## Determination 2012/021

### Regarding the refusal of a code compliance certificate and the issue of a notice to fix for alterations to a house at 26 Benson Road, Remuera, Auckland

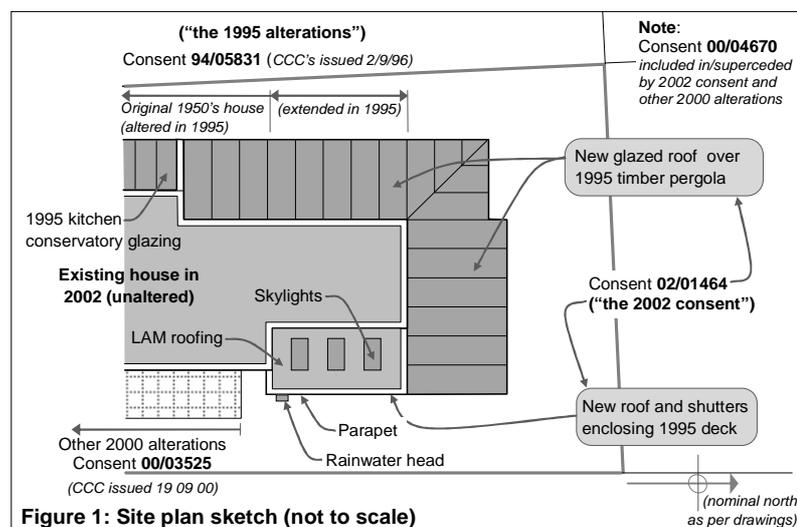
6.4.2 The expert noted that the weatherproofing of the 1995 plastered balustrade framing is dependent on the flashing tape applied to the balustrades top. Although scupper defects are likely to have caused the highest moisture level of 28%, the expert considered that further investigation is needed to establish cause(s) of the elevated moisture levels under the shutter sills, as they may relate to other defects. (refer to paragraph 6.8.1)

2.3.1 The subject alterations were carried out under the 2002 consent and incorporated the pergola glazing originally covered by AC/00/04670. The 2002 alterations are shown in the sketch in Figure 1:

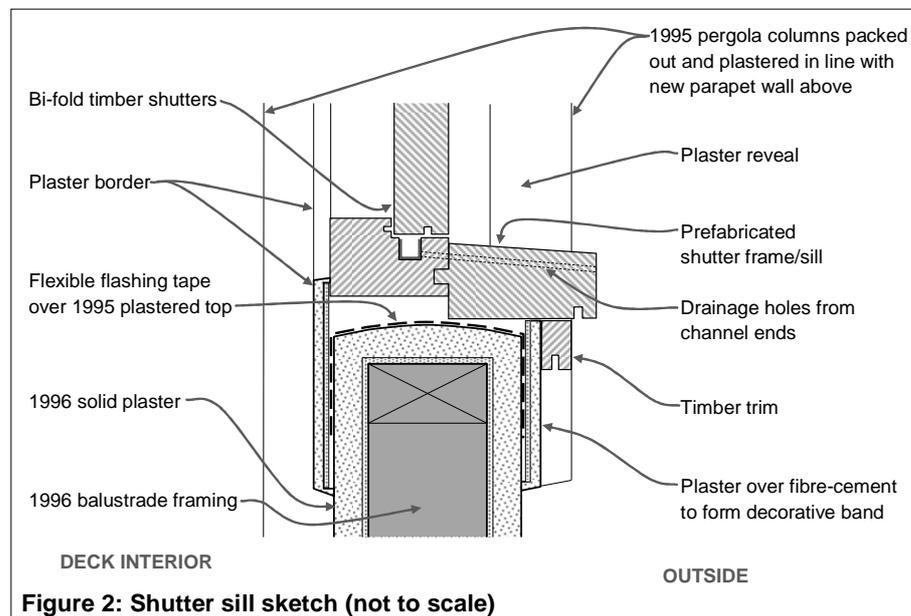
- 6.8.1 Commenting specifically on the claddings, the expert noted that:
- the roof membrane is thinly applied, with glass fibres clearly visible (this indicates the membrane was not well installed and could be prone to leaks)

- the scupper forms a lip at the opening and causes ponding, with the membrane deteriorating at the opening, high moisture levels, and stains on column plaster

- there is no drip edge to the plastered reveal above the shutter heads
  - further investigation is needed into the cause(s) of elevated moisture levels under the sills (16% and 19% in comparison with the 10% at the head level), which may result from one or a combination of:

- moisture penetrating at shutter jamb/plaster reveal junction
    - insufficient drainage provided from the shutter channel
    - moisture penetrating at the shutter sill/wall junctions

- penetrations through underlying 1995 elements(I note here that investigation should include whether mechanical fixings to the new sill penetrate the existing plaster.)

- the junction between the pergola glazing and the 1995 kitchen wall and conservatory glazing is not sufficiently weathertight and may allow rain to drive into the wall beneath.

7.4.3 Because the identified faults occur in discrete areas, I am able to conclude that satisfactory investigation and/or rectification of areas outlined in paragraph 6.8.1 will result in the alterations being brought into compliance with Clause B2 of the Building Code.
